ECE/TRANS/WP.29/GRSP/2007/15
28 September 2007

REGULATION No. 29
(Cabs of commercial vehicles)

Proposal for draft 03 series of amendments

Submitted by the expert from Sweden ^{*/}

Model A

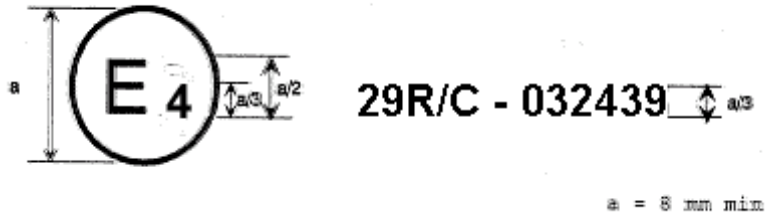
Note: The marking picture not modified

The above approval mark affixed to a vehicle shows the vehicle type concerned has with regard to the protection of the occupants of the cab of a commercial vehicle, been approved in the Netherlands (E 4), under the number **03249** ~~02249~~ and that the cab of the vehicle ~~meets the requirements of test C.~~ The first two digits of the approval number indicate the Regulation No. 29 already included the **03** ~~02~~ series of amendments when the approval was given.

Model B

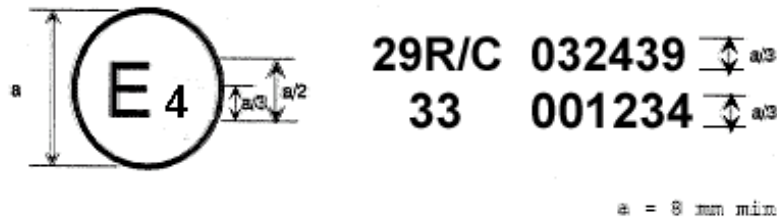
Note: The marking picture not modified

The above approval mark affixed to a vehicle shows that the vehicle type concerned has been approved in the Netherlands (E 4) pursuant to Regulations Nos. 29 and 33. 1/ ~~The cab of the vehicle meets the requirements of test C.~~ The approval numbers indicate that on the dates on which these approvals were granted, Regulation No. 29 included the 03 series of amendments and Regulation No. 33 was in its original version.

Fig. 1

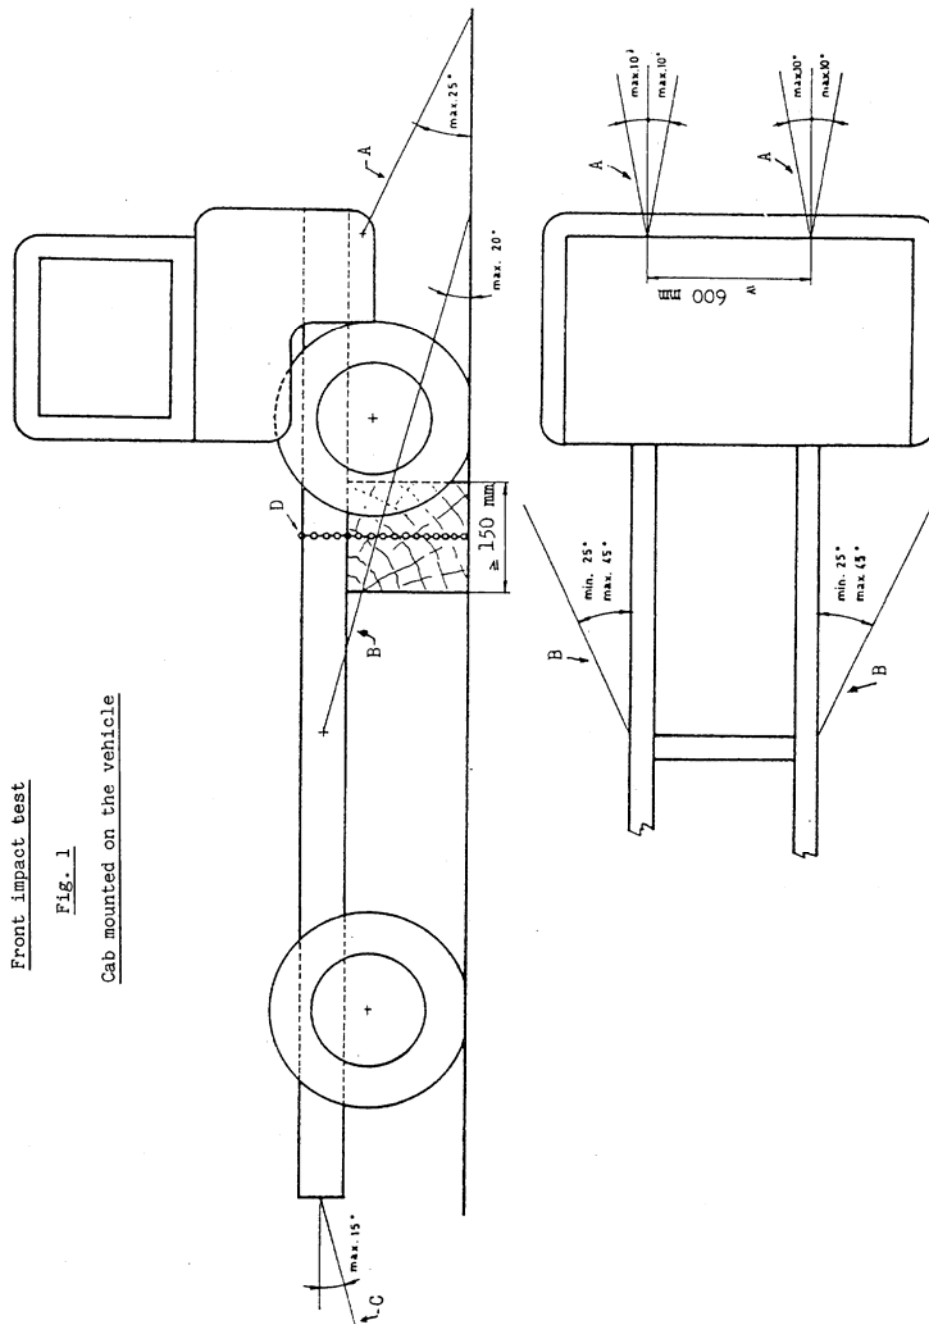
~~Test A shall be applied to a cab mounted on the vehicle in the following way (see figure 1 below).~~

~~Rearward movement of the chassis frame shall be limited by chains or ropes A attached to the front of the chassis frame symmetrically in relation to its longitudinal axis, the points of attachment being not less than 600 mm apart. The chains or ropes shall when tensioned form a downward angle of not more than 25 ° with the horizontal and their projection on a horizontal plane shall form an angle of not more than 10 ° with the longitudinal axis of the vehicle. The chains or ropes may cross one another.~~

~~Lateral movement shall be limited by chains or ropes B attached to the chassis frame symmetrically in relation to its longitudinal axis. The points of attachment to the chassis shall be not more than 5 m and not less than 3 m from the front of the vehicle. The chains or ropes shall when tensioned form a downward angle of not more than 20 ° with the horizontal and their projection on a horizontal plane shall form an angle of not less than 25 ° and not more than 45 ° with the longitudinal axis of the vehicle.~~
